STATE OF HAWAII
DEPARTMENT OF LAND AND NATURAL RESOURCES
DIVISION OF FORESTRY AND WILDLIFE
1151 PUNCHBOWL STREET, ROOM 325
HONOLULU, HAWAII 96813

June 28, 2019

SUBJECT: Comments on Alexander and Baldwin, Inc. applications for stream diversion works permits for abandonment.

Figure 2. Grate to be sealed (left). Accessory pump house above grate (right).

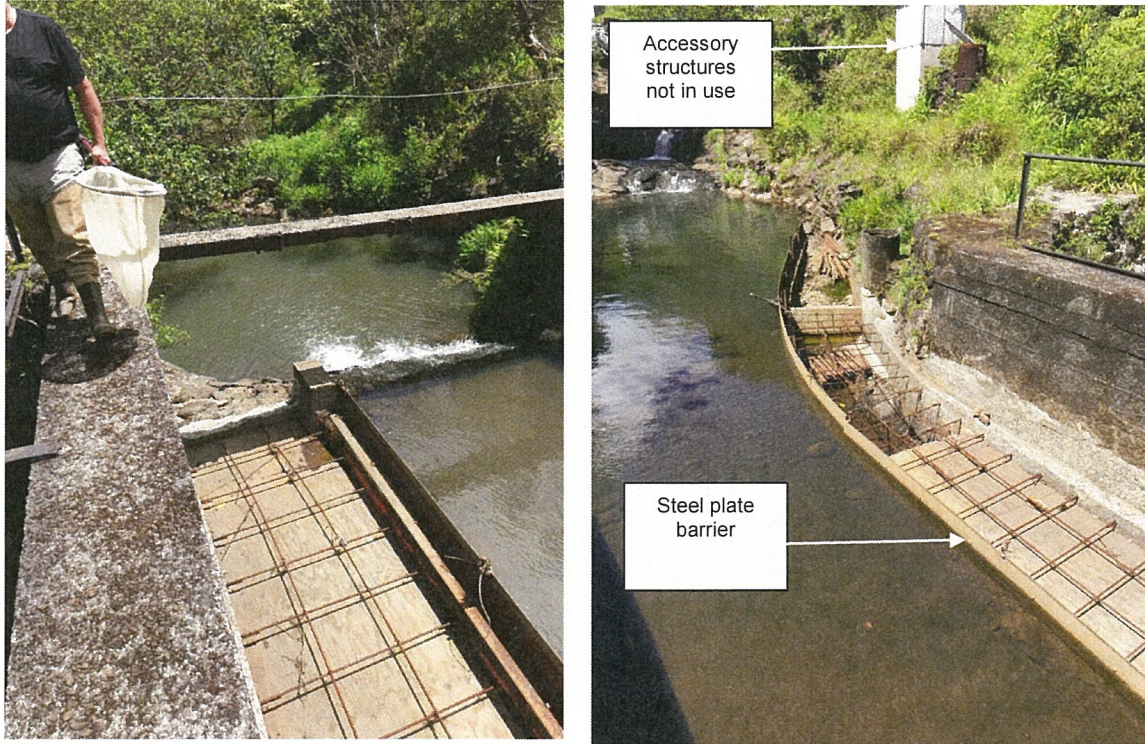
(1) Comments

- (a) Diversion located in Koolau FR
- (b) Grate on the west side of stream captures water for diversion. Application proposes to seal grate by filling with concrete.

(2) Recommendations

- (a) After the grate is sealed, the steel plate should be removed and sufficient concrete should be used to ensure that stream flow is continuous over the grate area and water cannot become trapped and stagnant, creating breeding sites for mosquitoes.
- (b) Remove any accessory structures not in use, such as the pump house shown in the figure below.

Figure 3. Road crossing tributary would appear to be prone to high levels of erosion.

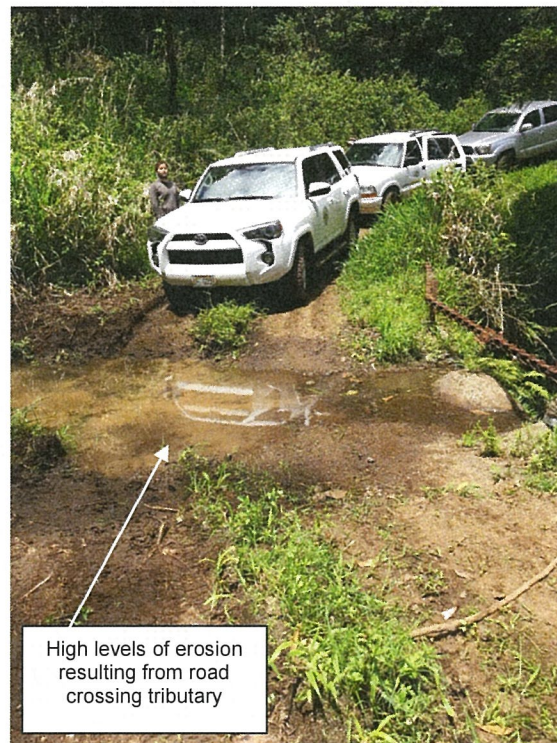
(1) Comments

- (a) This diversion is on EMI lands.
- (b) The tributary feeds Honopou stream, which runs through the Koolau Forest reserve.
- (c) The road crossing this tributary to Honopou stream appears to be prone to high levels of erosion.

(2) Recommendation

- (a) Please assess erosion and impacts to water quality resulting from this location and consider installation of a concrete swale or other measures to control erosion.

Figure 6. Location where tributary will cross the access road.

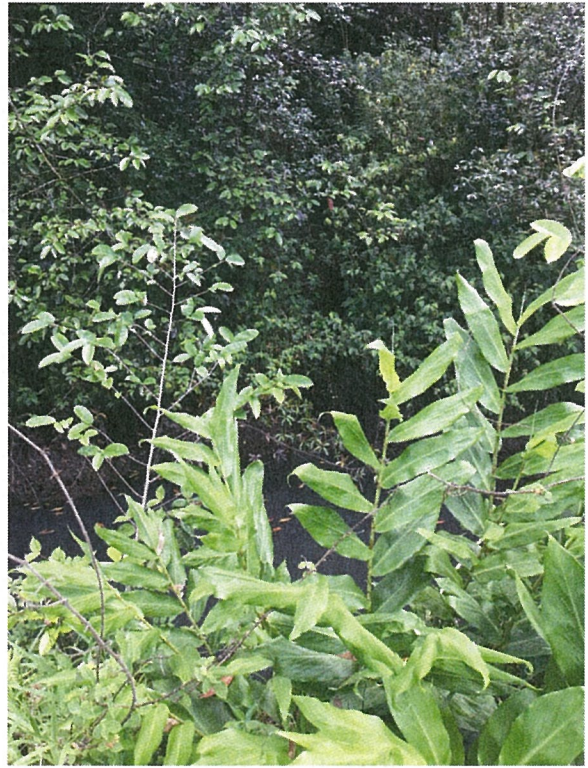
(1) Comments

(a) Located in Koolau FR

(b) This tributary enters the New Hamakua ditch where the access road runs along and makai of the ditch. The application proposes to install a stream bypass to enable the tributary to cross over the ditch.

(c) The stream must also cross the road and the application does not describe how that will be constructed.

(2) Recommendations

(a) The methods employed to enable the stream to cross the road should ensure that erosion of the road is avoided. This may be done by installing a concrete swale or by installation of a culvert of appropriate diameter under the road.

Figure 8. East Wailuanui at Koolau ditch (K-18). Stagnant water outside the west wall (top left), wall crossing stream (top right), stagnant water on the east side of the stream.

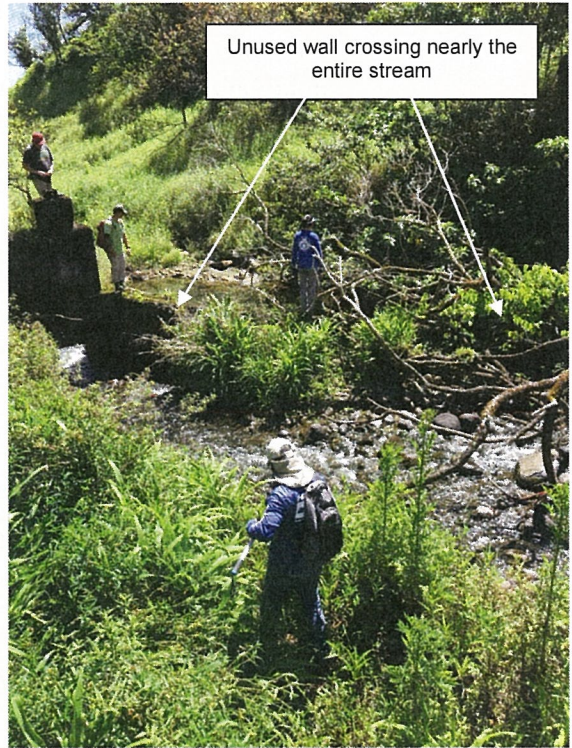
(1) Comments

(a) This diversion consists of walls on both sides of the stream that divert the stream into the ditch on the west side of the stream. The east wall crosses nearly the entire stream bed to divert the water to the west.

(b) The walls trap standing water on both sides of the stream, as well as in the intake, which we found to be very stagnant, creating breeding sites for mosquitoes. The application proposes to permanently remove the sluice gate to restore stream flow and to fill the intake with concrete.

(2) Recommendations

(a) Remove the walls on the east and west side of the stream in their entirety. Those walls will no longer be used for diversion purposes and their presence creates large areas of stagnate water that creates breeding sites for mosquitoes.

(b) Ensure that sufficient fill material is used for the intake to ensure that water does not become stagnant in the intake.

(c) Remove the pillar and structures at the intake since they will no longer be used for water diversion purposes.

Figure 9. Channel to enable stream to cross ditch (left). Control house at K-19 (right).

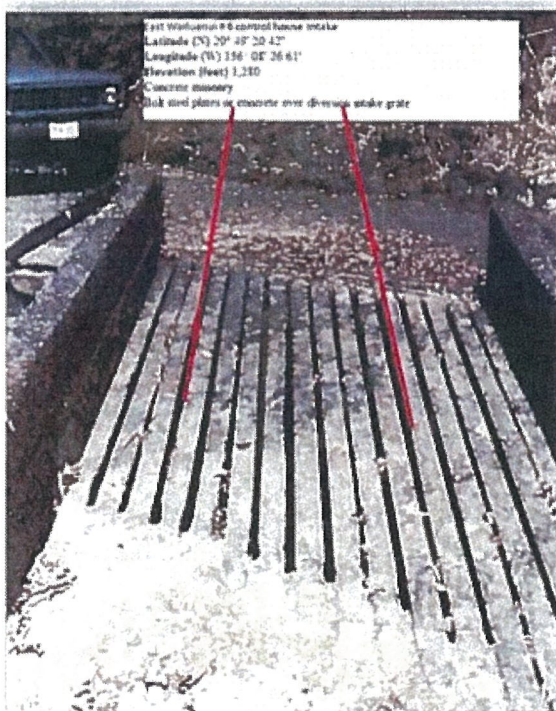
(1) Comments

- (a) Diversion consists of walls that channel the stream flow over the ditch where a collection grate allows the water to fall into the ditch.
- (b) The application proposes to cover and seal the grate so that water will continue downstream.

(2) Recommendations

- (a) The channel that is created by the walls is relatively narrow and low. It is unknown whether it may should be monitored regularly to ensure that it does not become obstructed by debris.
- (b) The control house and related structures should be removed if they are no longer in use.
